## NOTICE OF ADDENDUM NO. 1

State of Rhode Island  
Solicitation Number 7553498  
CBLS Cooling Tower Improvements  
University of Rhode Island  
Kingston, Rhode Island

**DATE OF ADDENDUM:**                    **June 9, 2017**

# APPENDIX A

15 WALL SECTION DETAIL  
 @ WEST MASONRY WALL  
 SCALE: 1-1/2" = 1'-0"

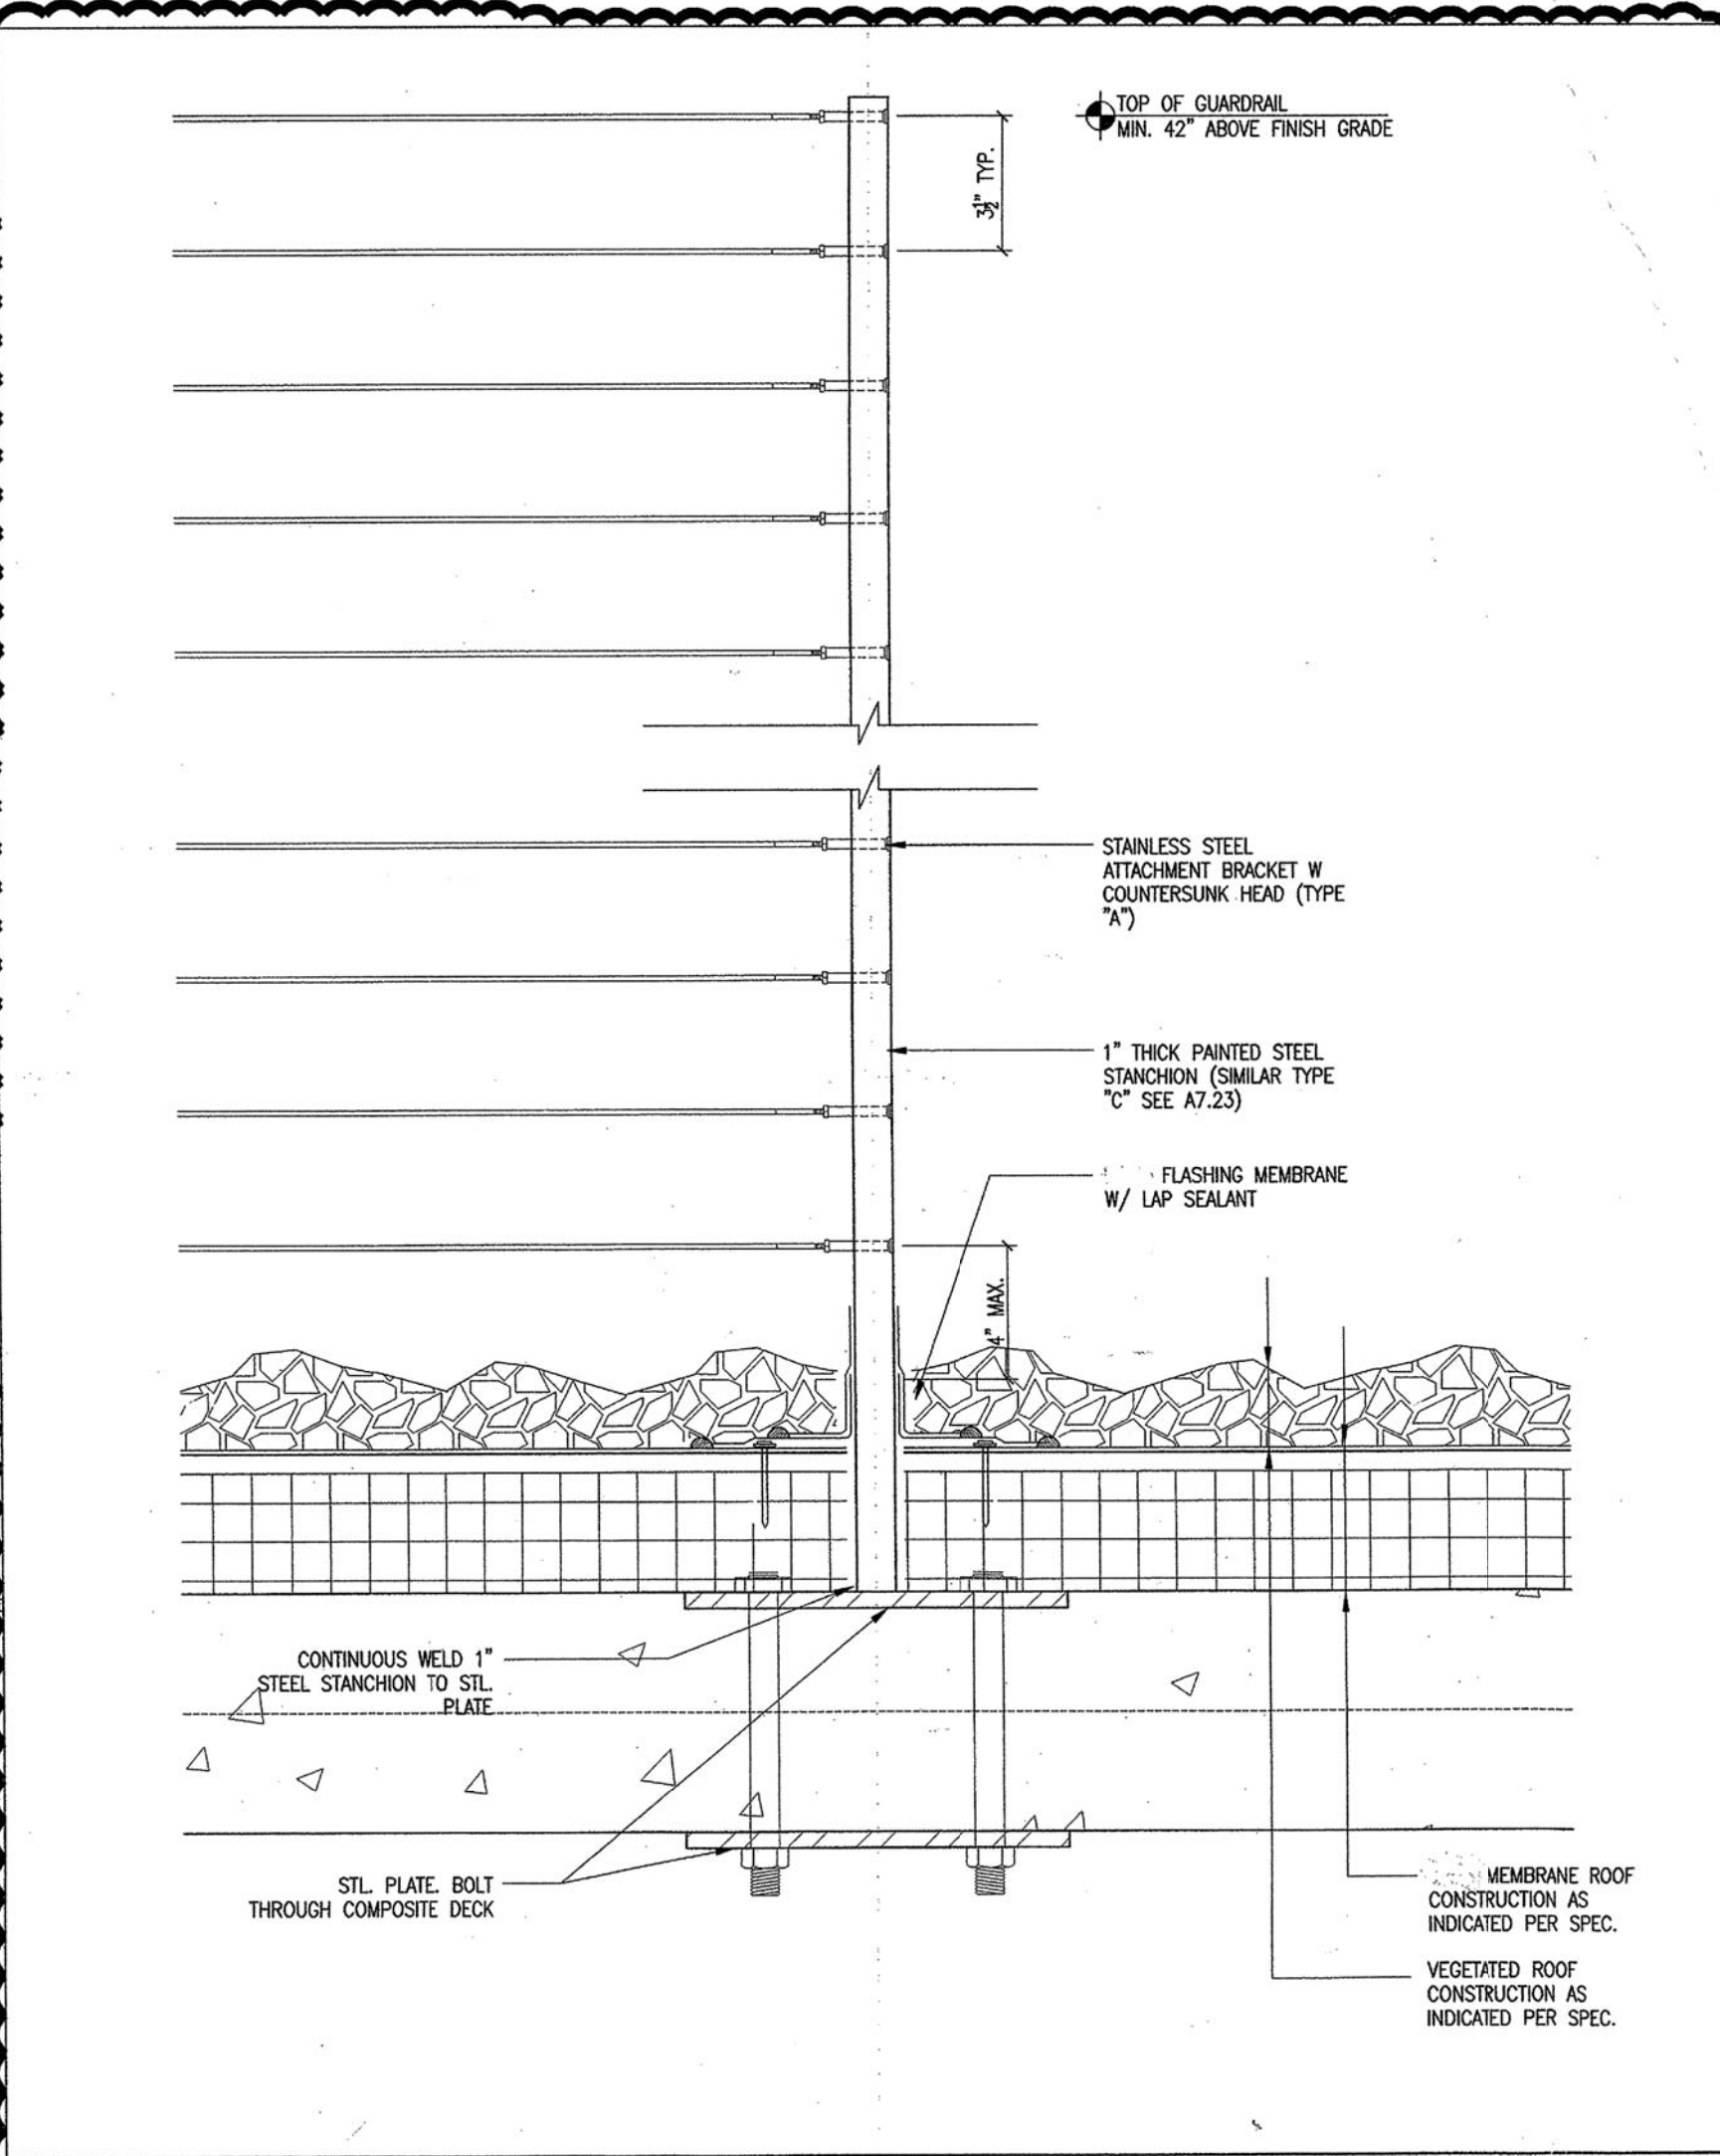
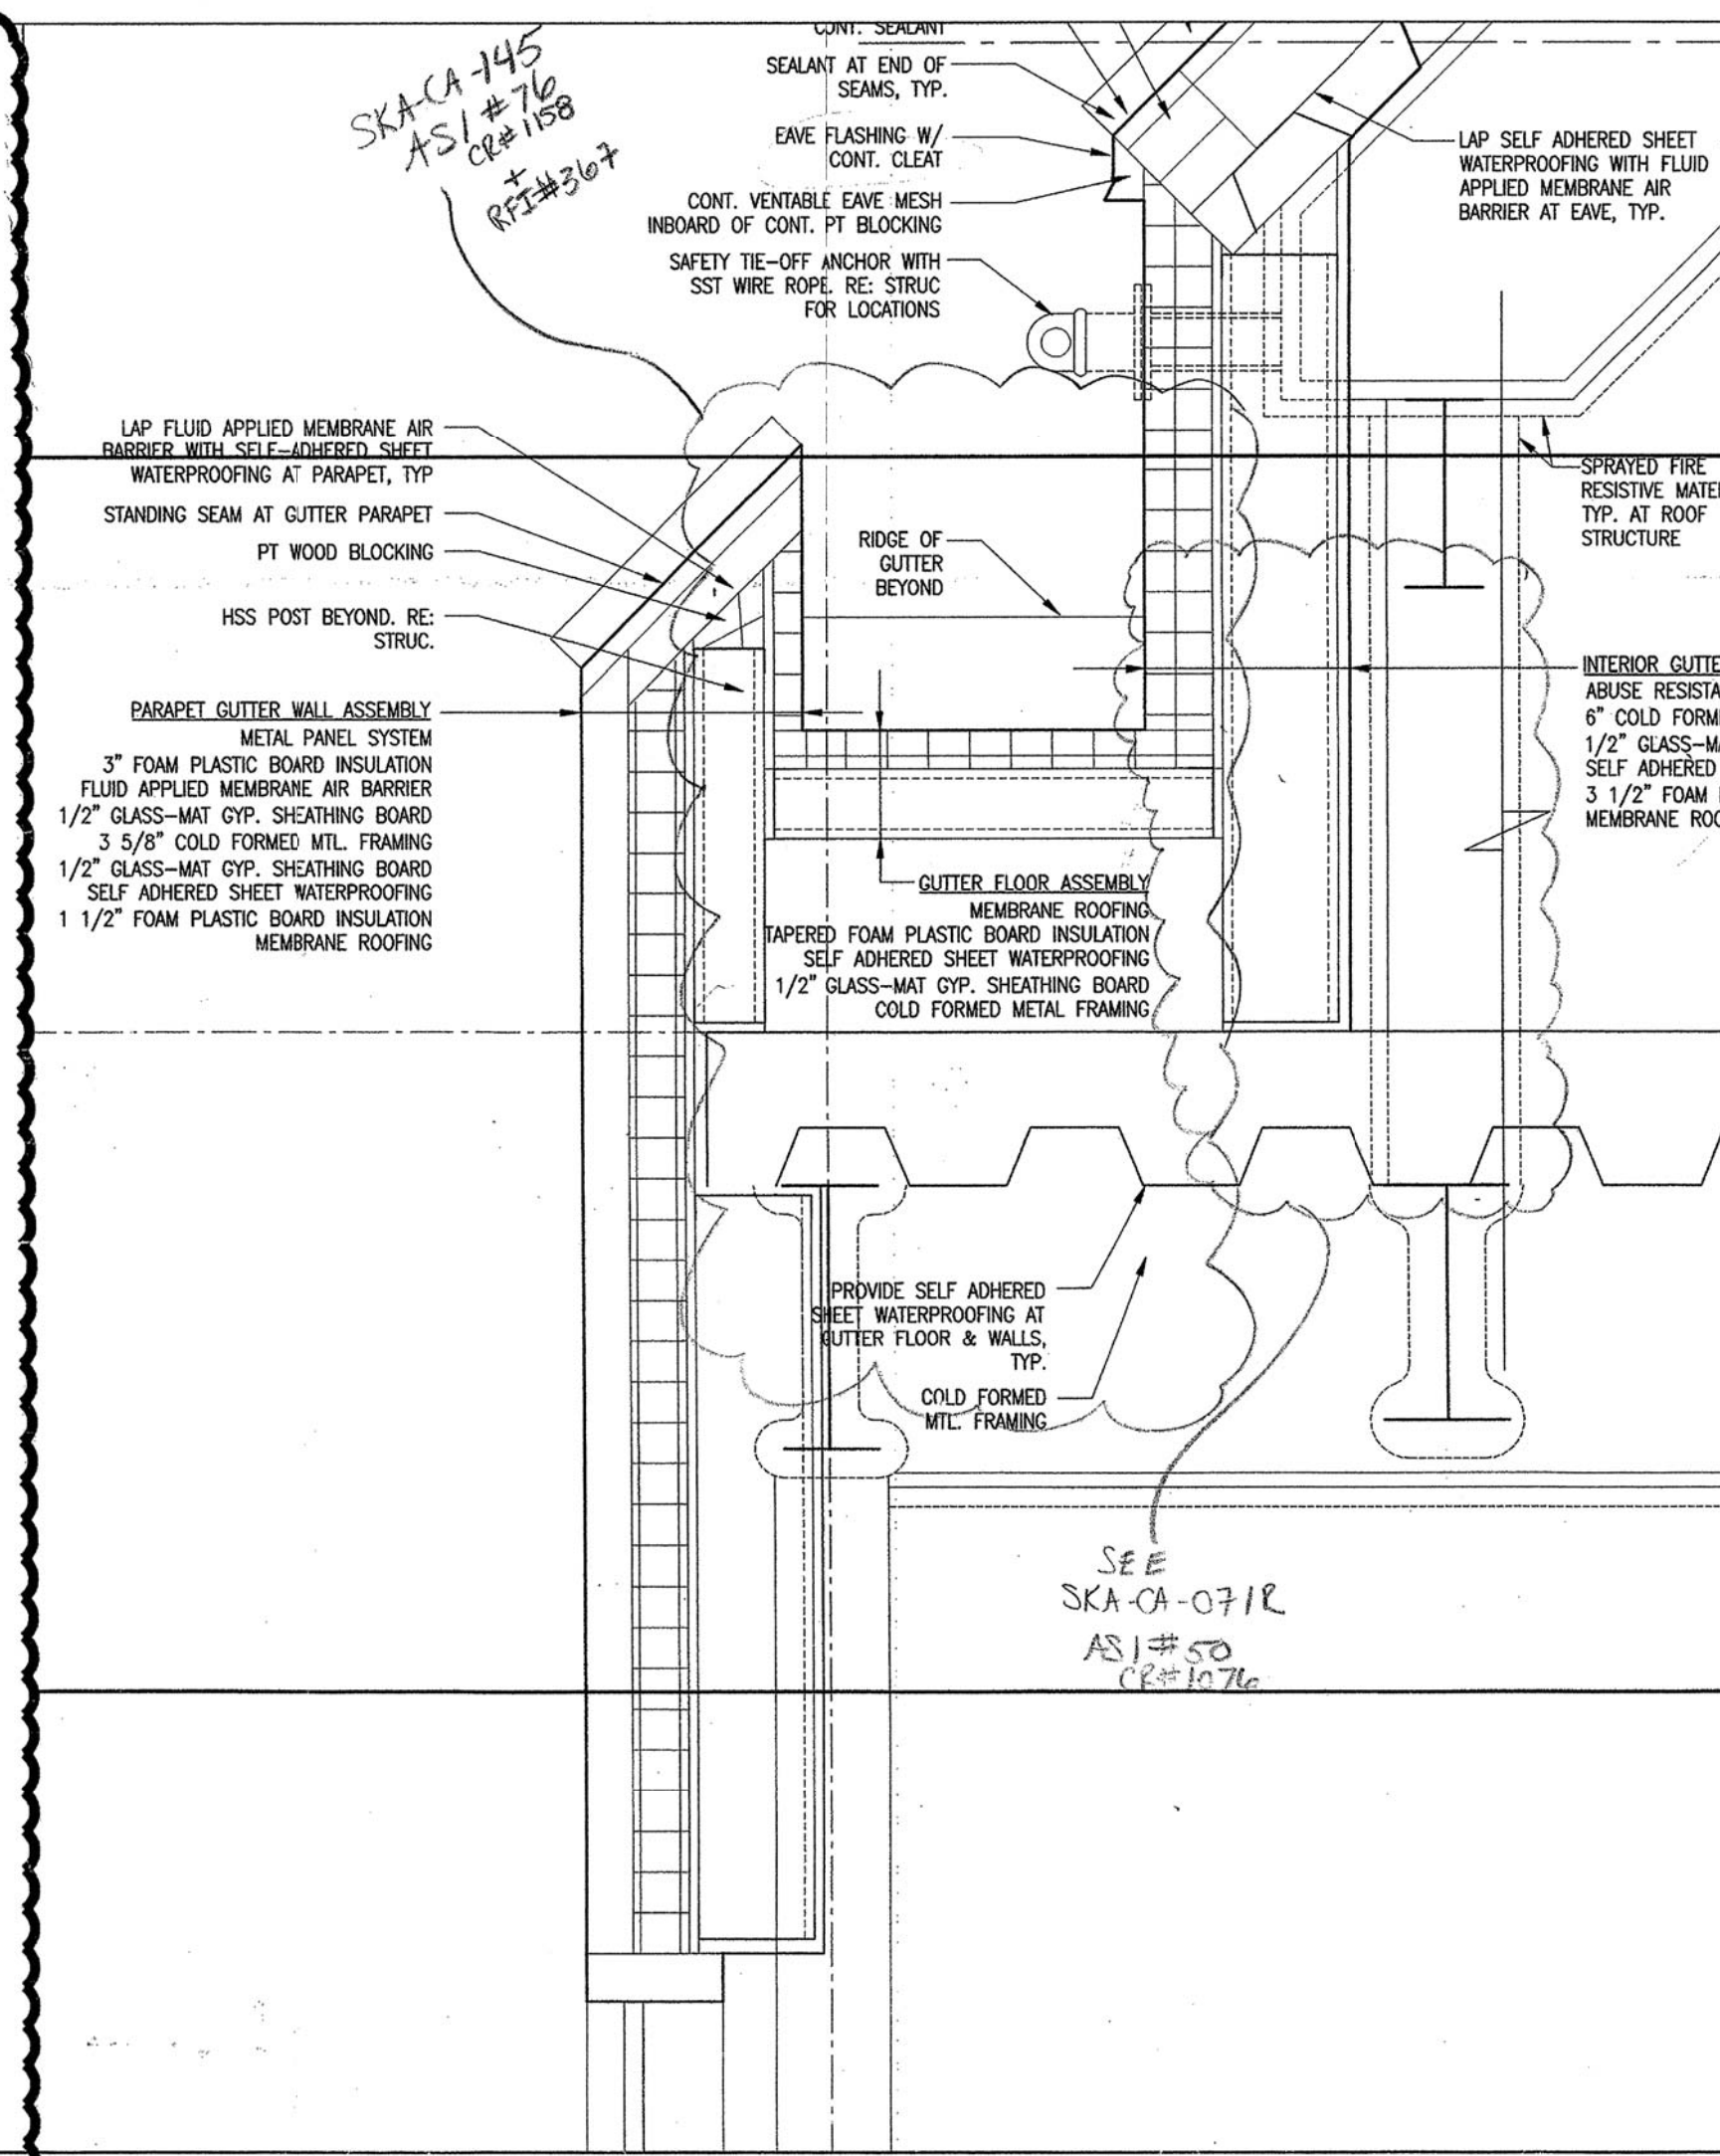
**Notes:**  
 For Installation of New Fall Protection System:  
 - Remove existing roofing at locations identified to receive new roof anchors;  
 - Create openings in existing roof deck;  
 - Install roof fall protection anchor system per manufacturer's requirements;  
 - Repair roof deck - provide drawings for review and approval by structural engineer;  
 - Repair roof membrane, protection board, membrane flashing and green roof assembly at all roof openings to match original conditions.
